*Trail Mtn. Coal Co.*  
*ACT/015/019*

Subject: Cottonwood Fan Portal Hydrology

COTTONWOOD FAN PORTAL

HYDROLOGICAL DESIGN

**COTTONWOOD FAN POREAL  
AREA DRAINAGE MAP**

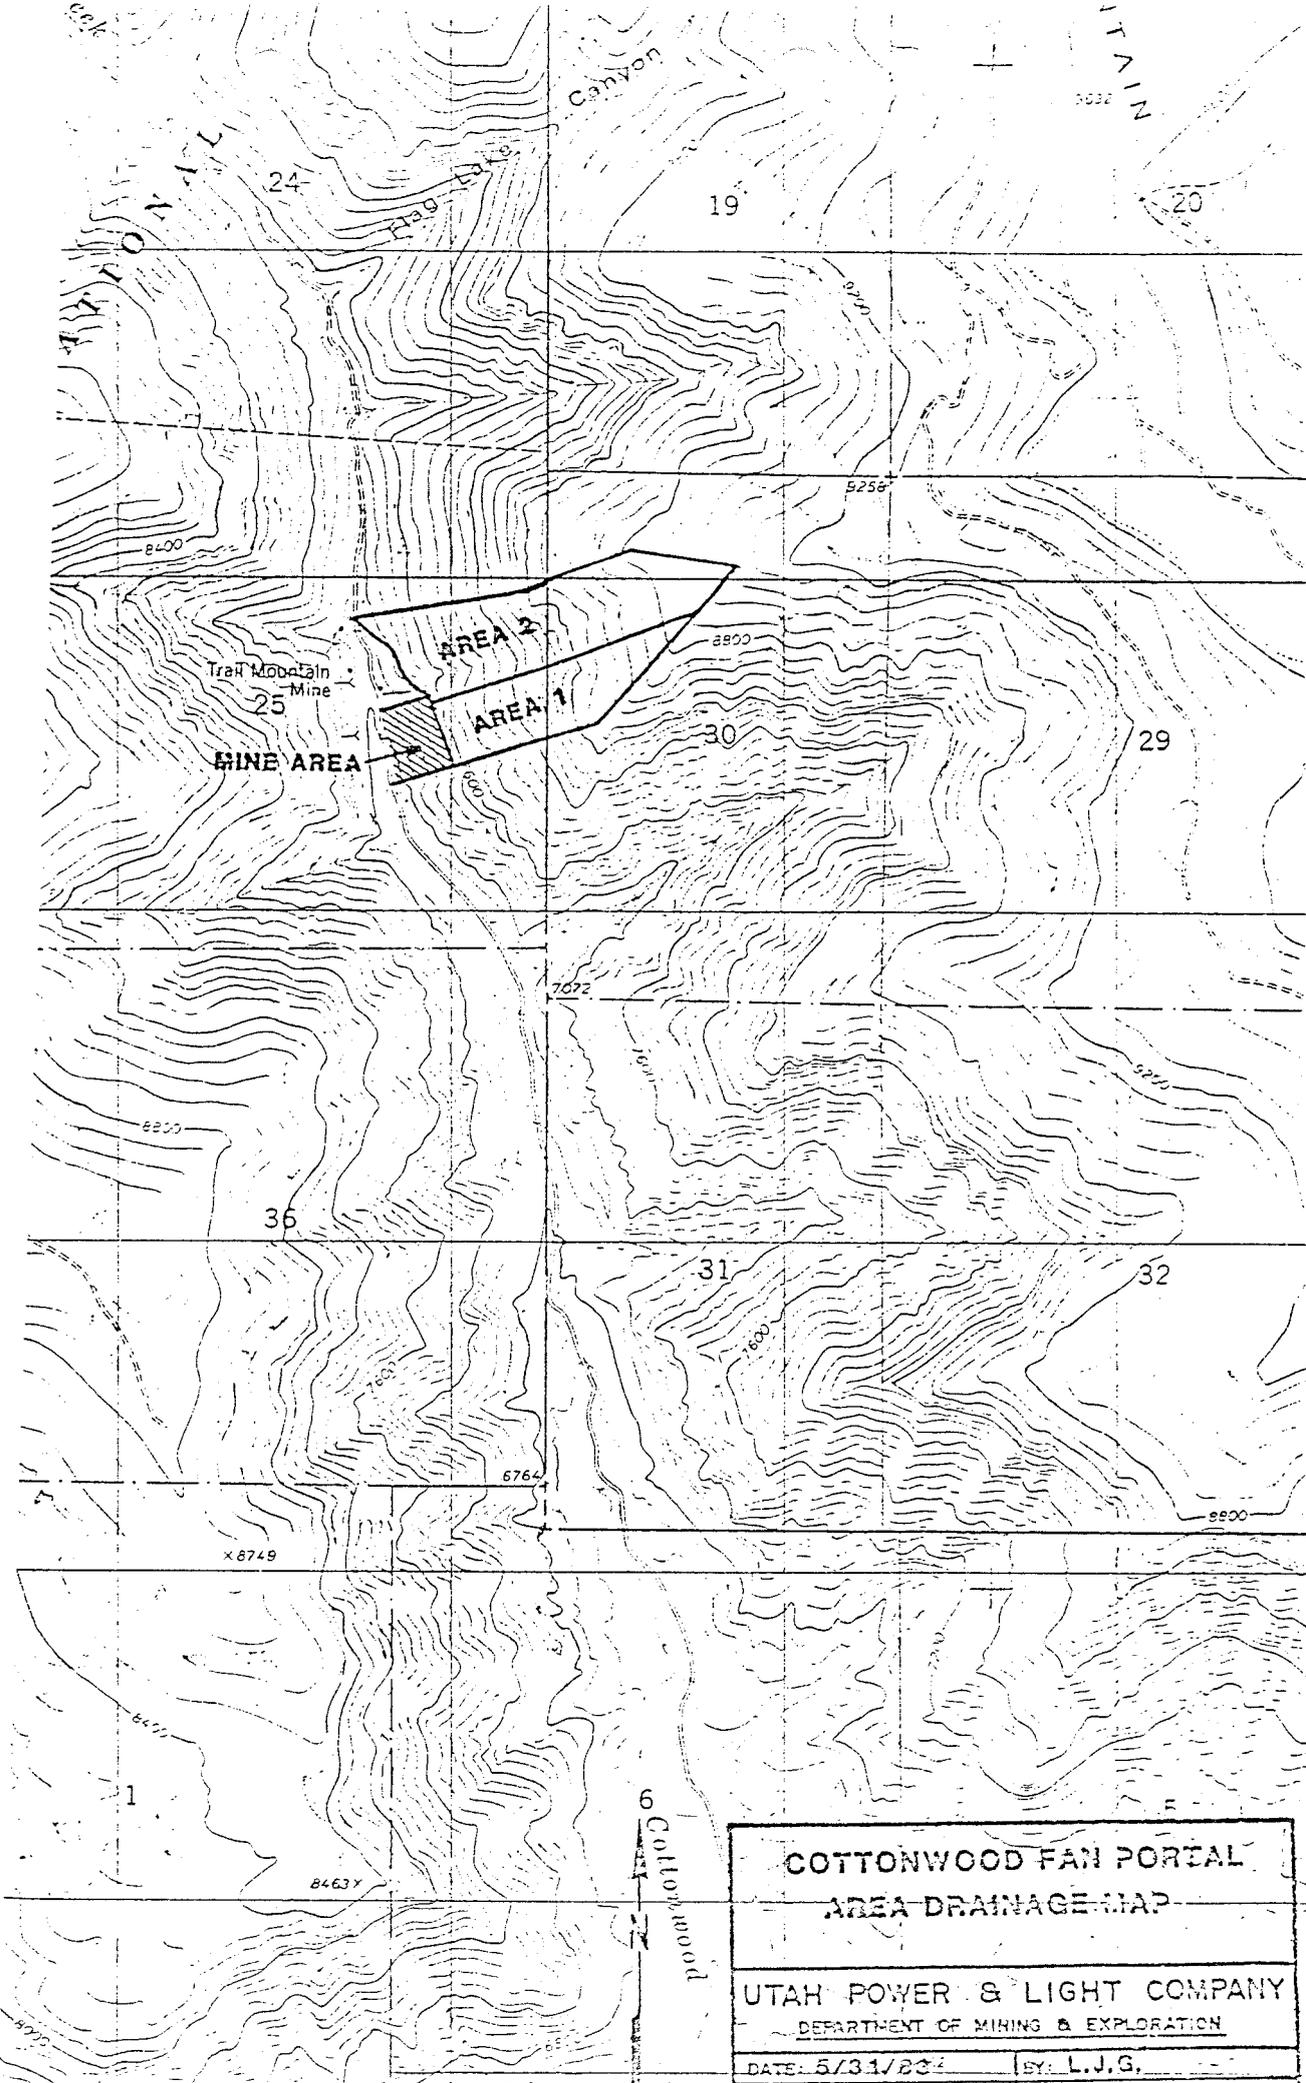
Present facilities include three small sedimentation ponds linked together for providing control of runoff water from three areas (see hydrological Map CM-10501-CP). They are: sub-area 6 and 7, topsoil and subsoil storage areas, sub-areas 3 and 4, the original disturbed area, and sub-area 5.

It is proposed to eliminate the lowest catch basin, which provides protection of a small 1.8 acre area, sub-area 5, and substitute the old catch basin with four (4) small gabions placed across the road drainage ditch. Placement and spacing of gabions are designed to divide the revegetated area into four equal parts of approximately .45 acres.

Drainages identified on drawing CM-10501-CP have been designed to utilize four separate culverts to conduit flows associated with the Cottonwood fan portal area. An existing 36 inch culvert designated C-1 and an unmarked 48 inch culvert to be installed by the county at station 147+00 will pass the undistributed runoff from areas 1 & 2, an area of approximately 95 acres.

**TYPICAL GABION**

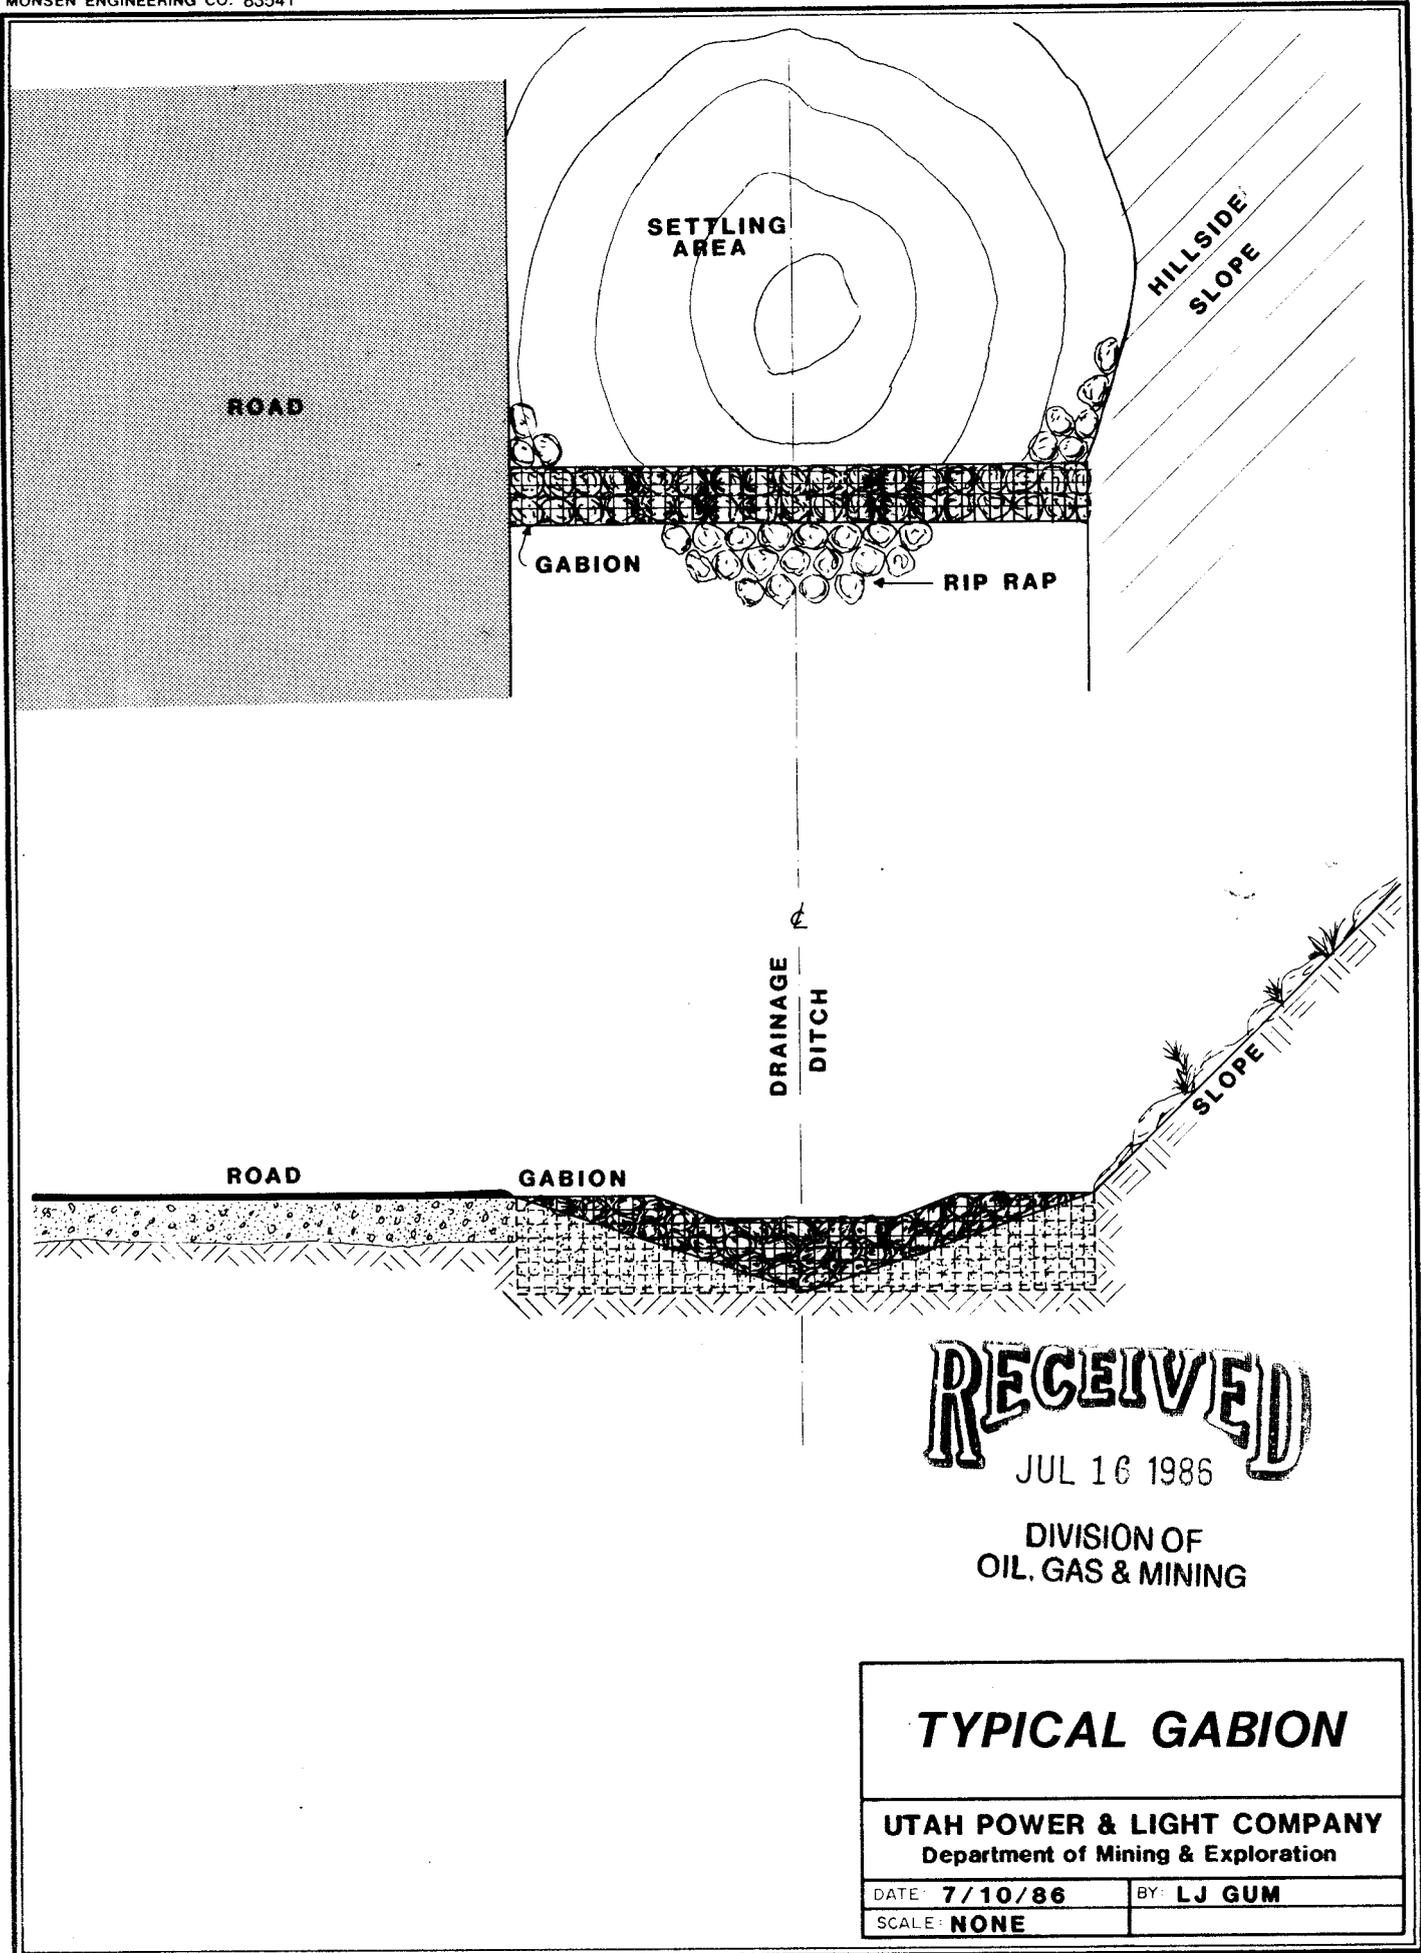
Construction of the gabion will coincide with construction of the new county road and will be built as shown on the included drawing. Cleaning will correspond to the rate of runoff and sediment accumulation. For gabion placement and road centerline location refer to "Proposed Cottonwood Road Alignment - Proposed UP&L Drainage System" map.

It has been judged that pooling of the gabions afford at least the same or better water treatment than did the old sedimentation catch basin. Diversions will consist of open ditches and culverts sized and placed as shown on the highway location drawing and the hydrological map enclosed. Runoff values are taken as shown in the text and derived from calculations formed in Appendix XIX.
